## AGENDA

Planning Committee Meeting to be held  
at Darebin Civic Centre,  
350 High Street Preston  
on Monday, 10 July 2017  
at 6.00 pm.

### 5.1 APPLICATION FOR PLANNING PERMIT D/877/2016 8 Ballantyne Street, Thornbury

**5.2 APPLICATION TO AMEND PLANNING PERMIT  
D/899/2015/A  
59 Howard Street, Reservoir**

*Figure 1: Rear Setback*

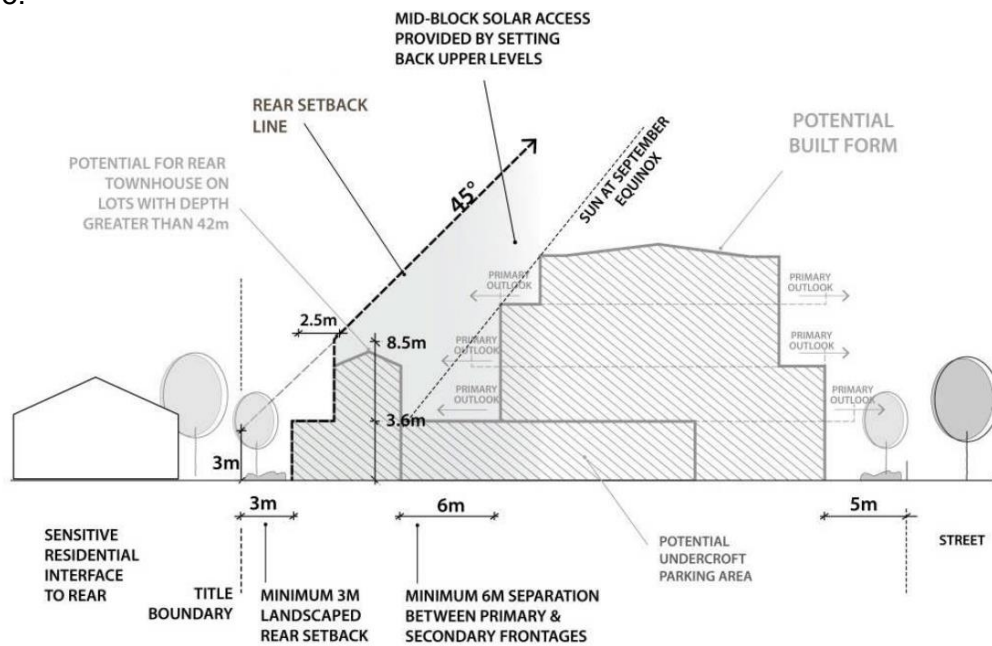
The DDO20 specifies that buildings should be set back from rear boundaries in accordance with the requirements of the zone and the principles shown in figure 2 below. The RGZ3 setback controls reflect this envelope. The RGZ4 controls require compliance with Standard B17. It is noted the requirements shown in Figure 1 are more restrictive than Standard B17.

With the exception of the top floor the setbacks from the rear boundary comply with the figure:
